# Continuation of Bengalla Mine

Response to Submissions

March 2014

Volume 1 Main Report

Hunter River Floodplain Cross Section - Plan View

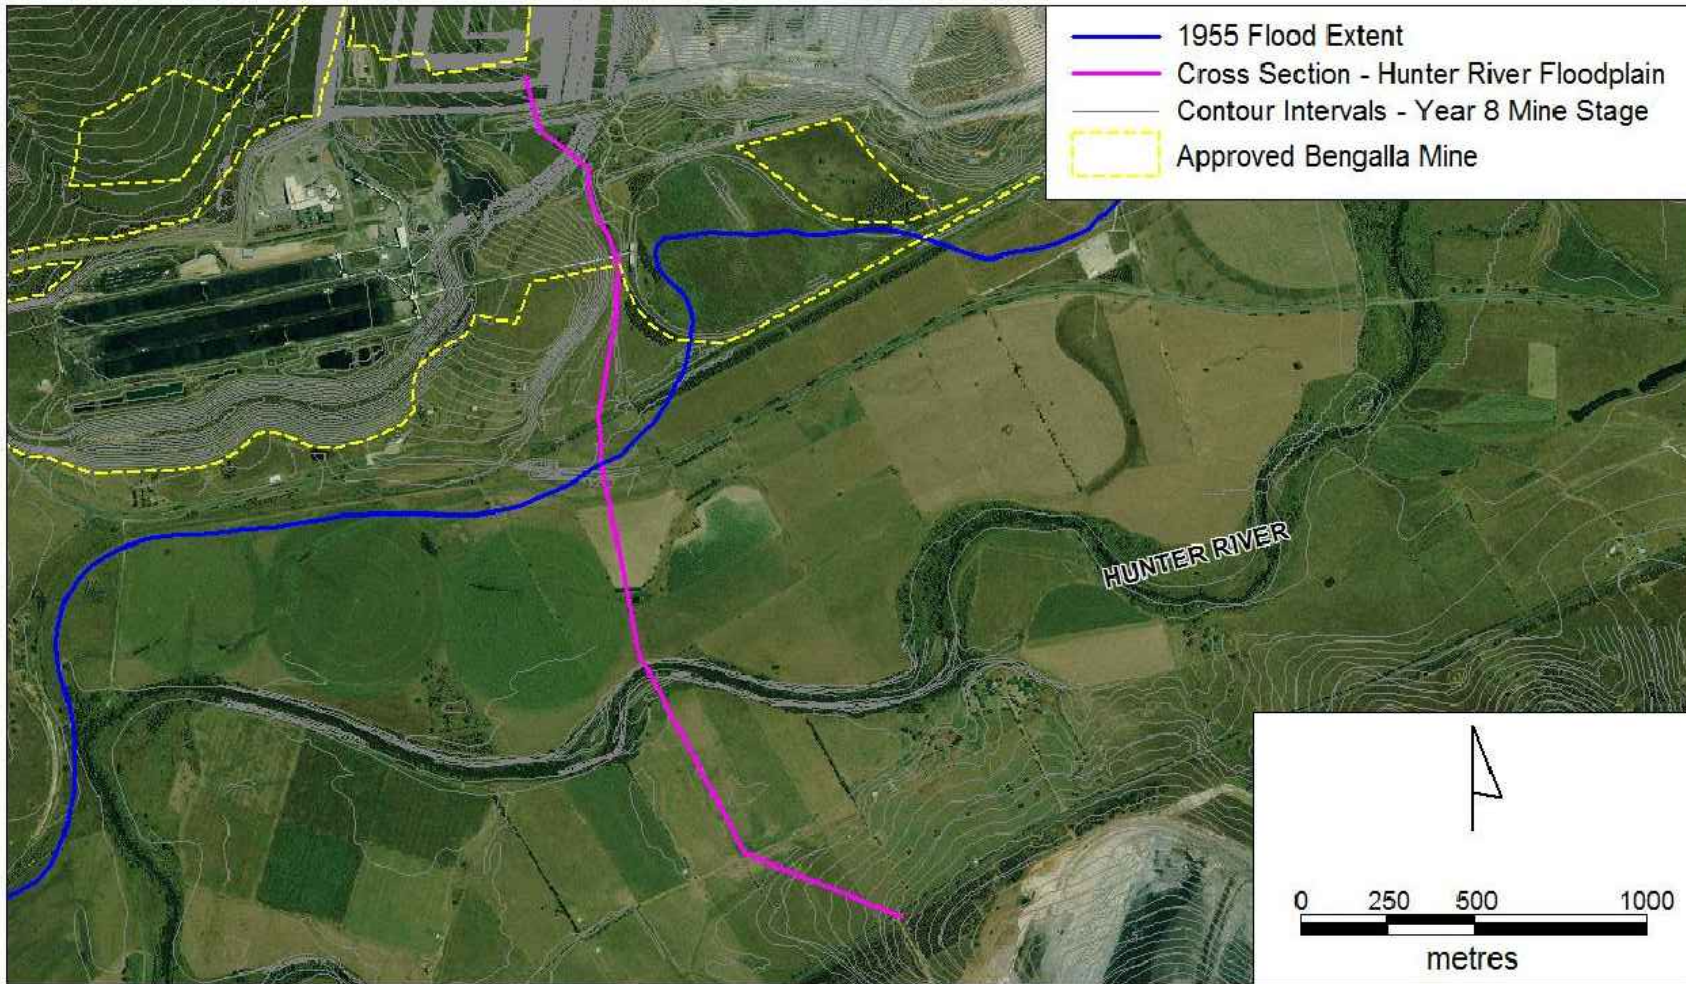
*The EIS does not...provide an assessment of the expected impact a flood would have if it should exceed the flood level that the project's mitigation measures have been designed to withstand.*

During Year 8 of the Project, the mining area will progress into the Dry Creek channel as shown on see **Figure 5**. Hunter River flood levels would need to exceed approximately RL 140 m to enter the Main Pit (approximately 5 m higher than the conservative estimate of the 100 year ARI flood event) via the culverts underneath the road embankment. If the culverts were removed, the water level would need to reach approximately RL 147 m to enter the mining area. A cross section of the Hunter River floodplain is shown in **Figure 6**.

An analysis of the cross sectional area of the Hunter River floodplain (see **Figure 5**) indicates a total area of approximately 3,000 m<sup>2</sup> at the 1955 flood level (adopted level of RL 136 m). During the Year 8 mining stage of operations, at the minimum overflow level to the open cut pit (RL 140 m), the cross sectional area of the Hunter River floodplain is about 12,000 m<sup>2</sup>, which is four times larger than the cross sectional area for the 1955 flood. Hence, at the same velocity the flow capacity of the Hunter River floodplain would be approximately four times larger than the 1955 flood discharge of about 4,000 m<sup>3</sup>/s. This means that the flood discharge to enter the open cut pit would be about 16,000 m<sup>3</sup>/s, which is much larger than the estimated 1,000 year ARI discharge of 7,200 m<sup>3</sup>/s. On this basis, the minimum flood immunity of the open cut pit at any time during operations is estimated to be significantly larger than the 1,000 year ARI flood.

**Figure 7**  
**Predicted Receiver Point Level vs dBC – dBA Difference**

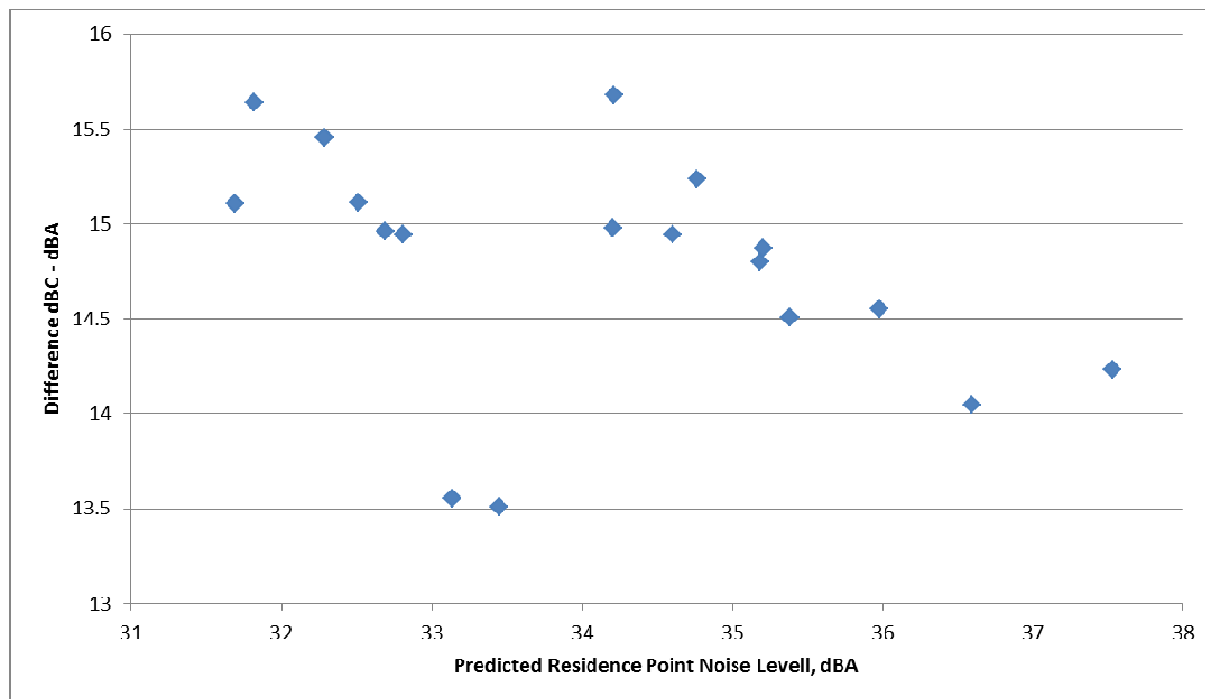
*The assessment predicts exceedances of the Project Specific Noise Levels (“PSNL”) that must be addressed by the proponent in accordance with chapters 8 and 9 of the Industrial Noise Policy (“the INP”). The EPA will then be in a position to recommend noise limits for all residences predicted to receive noise levels up to and including the PSNL. For any other receivers predicted to receive noise levels above the PSNL, the Department of Planning & Infrastructure (“DPI”) is best positioned to weigh the social and economic benefits of the proposal against potential adverse noise impacts and to determine if a higher noise limit is justified. If a higher noise limit is accepted by DPI following this assessment and consent is granted, the EPA will include these limits in the EPL.*

There is a fairly strong correlation between the predicted noise level and the dBC - dBA difference at each receiver, as shown in **Figure 7**. In general, receptors closer to the Project receive higher noise levels but are less likely to require a low frequency penalty according to the INP. This trend has the potential to create a 'quiet zone' at intermediate distances from an industrial development such as a coal mine, where receivers closer to the development are potentially affected by noise from the development and receivers at greater distances are considered potentially affected due primarily to the INP low frequency penalty.

Receptors in the 'quiet zone' would be just outside the area affected by noise from the development but would not require the low frequency penalty and would therefore remain on an island 'unaffected' by noise from the development. This hypothetical but possible situation is a natural consequence of a threshold-based rather than a progressive low frequency or other penalty.

The Acoustic Impact Assessment (Appendix H of the EIS) method of applying the low frequency penalty has effectively raised the predicted noise levels at mildly and moderately affected receivers near the Project by typically 2 to 3 dBA, which is considered reasonably appropriate given the marginal nature of the 15 dB threshold exceedances. Accordingly, as the Acoustic Impact Assessment (Appendix H of the EIS) method complies with the INP and avoids the risk of 'quiet zones' and other difficult to justify anomalies as described above, no further adjustments to the predicted noise levels are considered necessary.

**Plate 1**  
**Existing Landscape within Site B10**

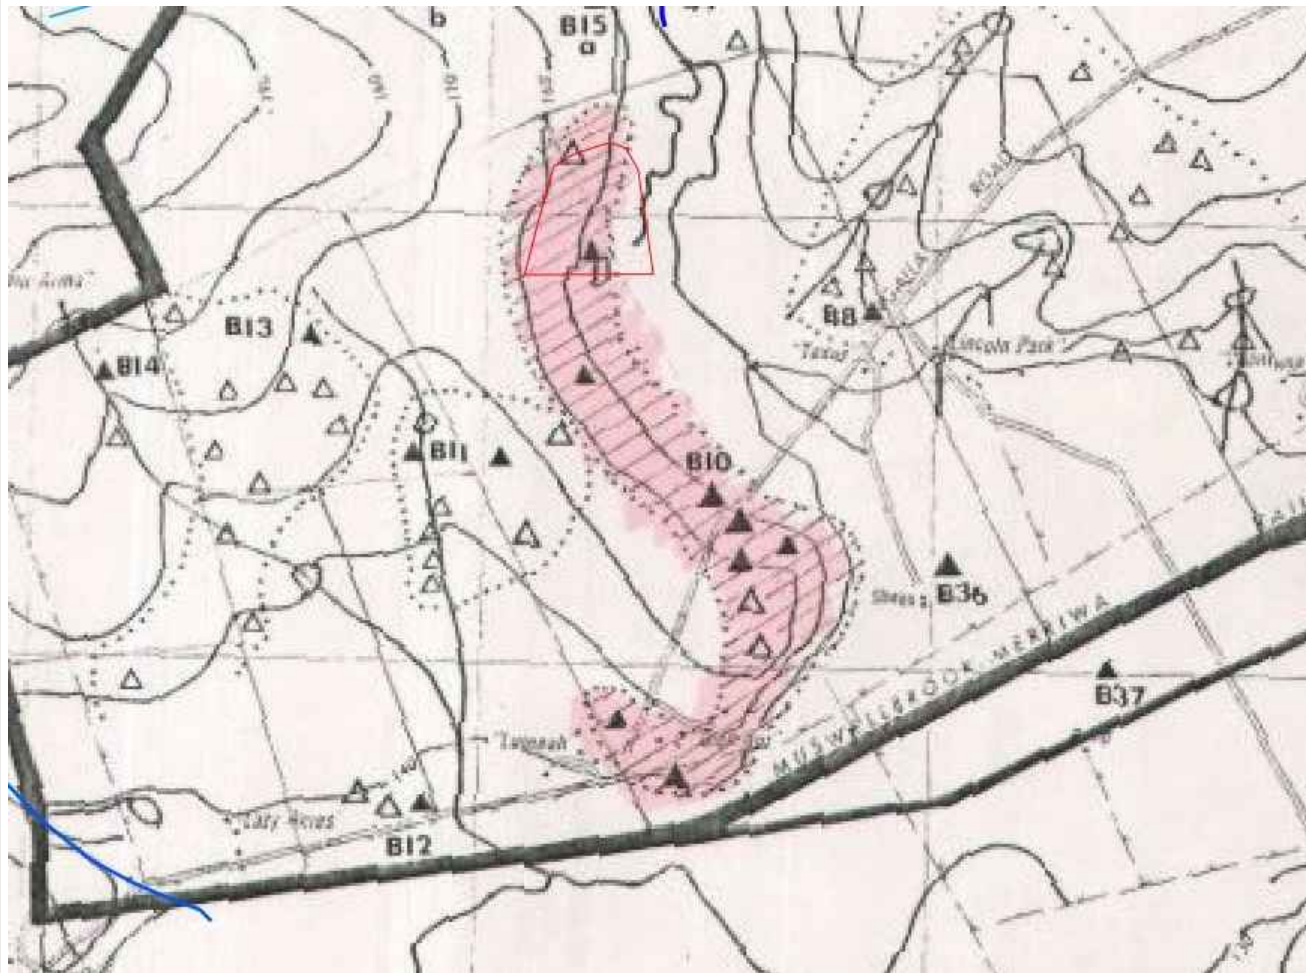
1. That interpretation of the type and extent of landform elements present within an area is an inherently subjective activity;
2. That the extent of the 'ridgeline' associated with B10 can be interpreted in a number of different ways; and
3. The original assessment completed by Rich (1993) did not conclusively map the extent of the tertiary ridge gravels associated with B10. Subsequent assessments, including AECOM's (AECOM, 2013), did not identify Tertiary ridge gravels in the northern exclusion zone consistent with those identified within the southern exclusion zone.

AECOM's (2013) review of available topographic data for the B10 northern exclusion zone and in-field observations indicate that this area incorporates two distinct landform elements: creek flat associated with Dry Creek and a gently inclined lower slope associated with a prominent hill 1 km to the west (see **Plate 1**). **Figure 8** shows Rich's (1993) original map of B10 - note, the hill to the west of the northern exclusion zone shown in red. On this basis, it is suggested that the B10 northern exclusion zone does not comprise part of what Rich (1993: 94) has referred to as a "long ridge".

FIGURE 14

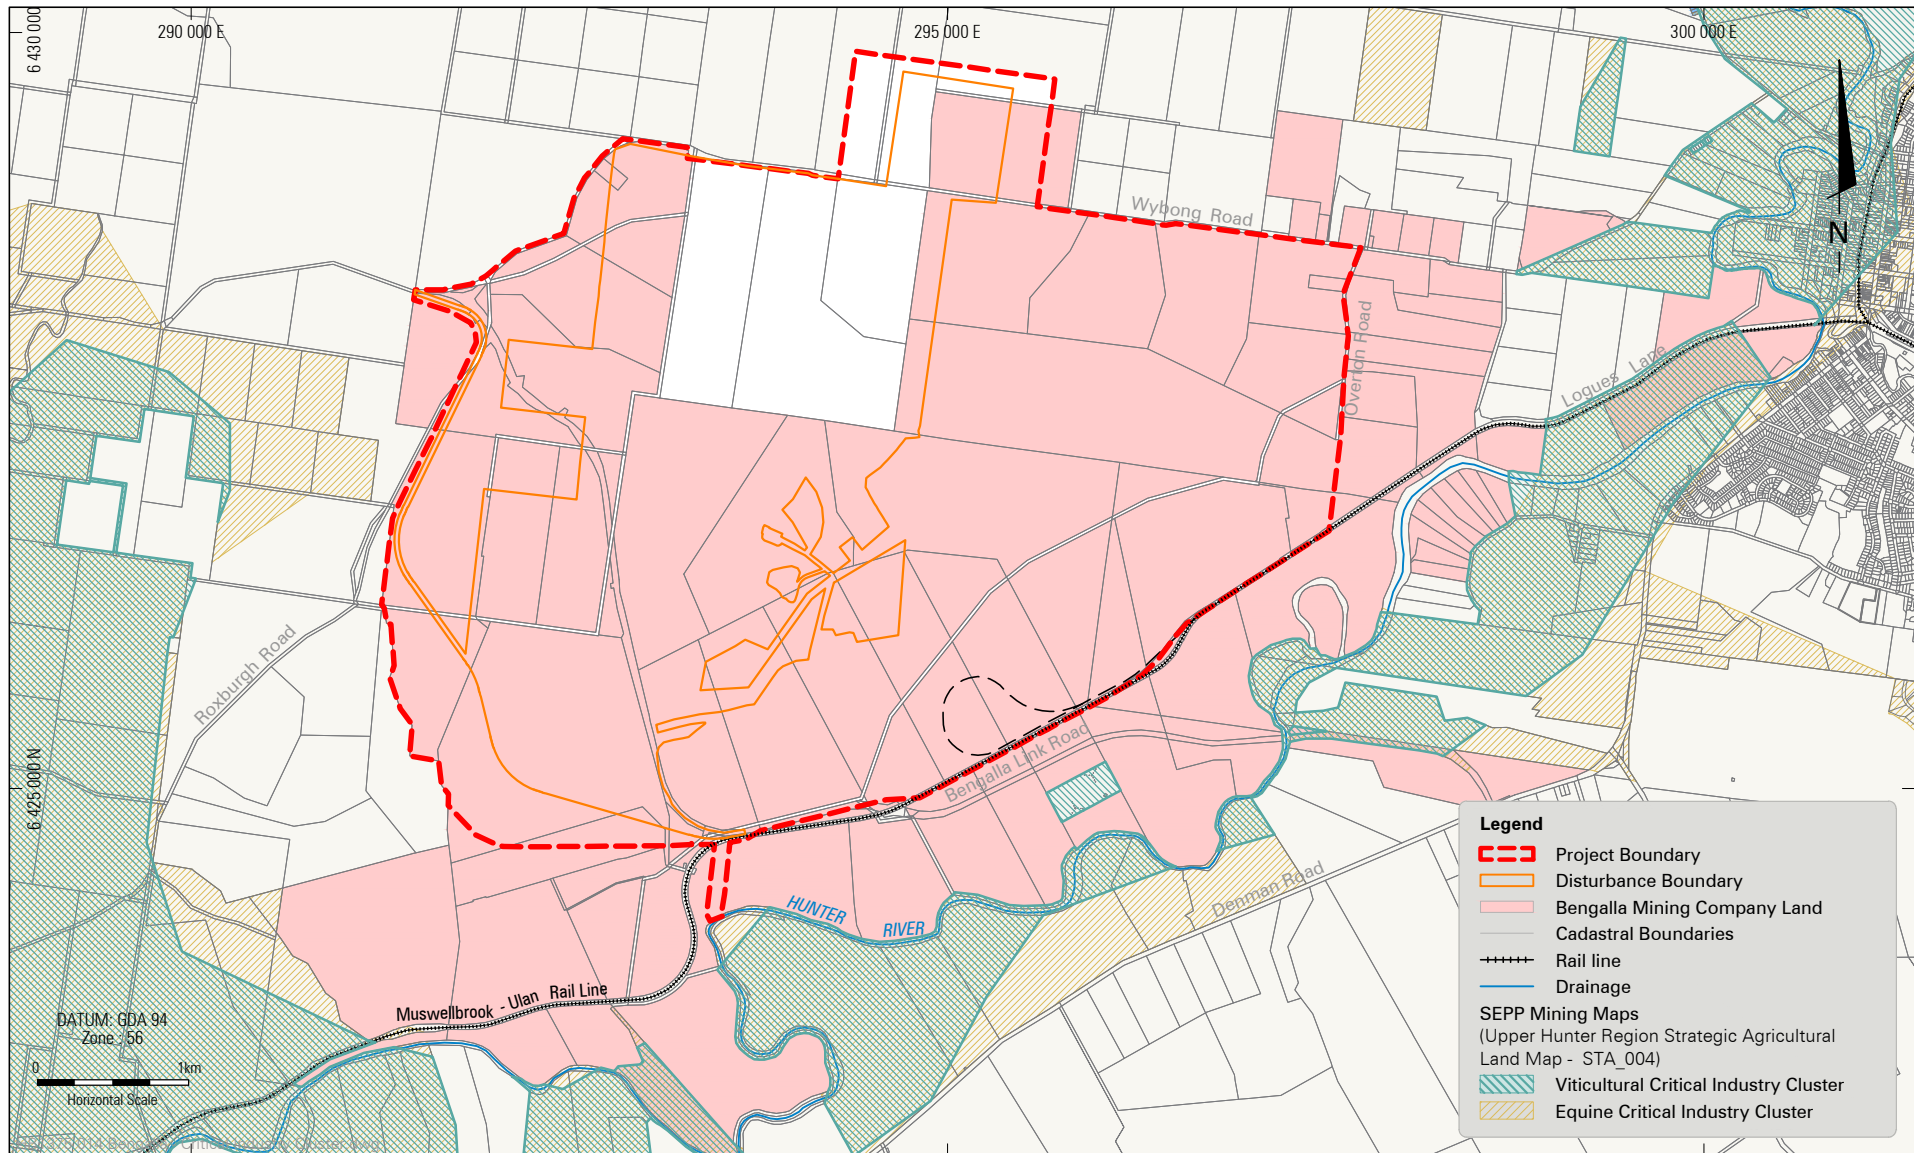
*It is No Response that mapped Strategic Regional Land Use Plan Lands (SRLUP) indicate 28 hectares is within the project area, while the verification investigation shows that only 1 ha is to be affected in the disturbance area. None of the 35 hectares of equine CIC in the project area is to be disturbed and 369 ha of the 494 ha viticultural CIC land identified by verification will be disturbed. The amount of these lands is considered to now be less with the amended maps available per the DP&I announcement in "Getting the Balance Right - NSW Land Use" in early October 2013. This aspect and the fact that the land is used for grazing with the nearest vineyard 6 kilometres south of the project area leads us to determine that the impact on the viticultural industry is minimal.*

On 28 January 2014 amendments were made to the SEPP Mining which included subsequent finalisation of the associated CIC Equine and Viticulture Mapping.

The relevant SEPP Mining map pertaining to the Project Boundary includes Upper Hunter Region Strategic Agricultural Land Map – STA\_004. The final CIC mapping has resulted in no areas of mapped Equine or Viticulture CIC located within the Disturbance Boundary or Project Boundary (see **Figure 14**).

The amendments to the Mining SEPP did not result in any changes to the previously identified land mapped as BSAL as presented in the EIS (see EIS Figure 30 and 67).
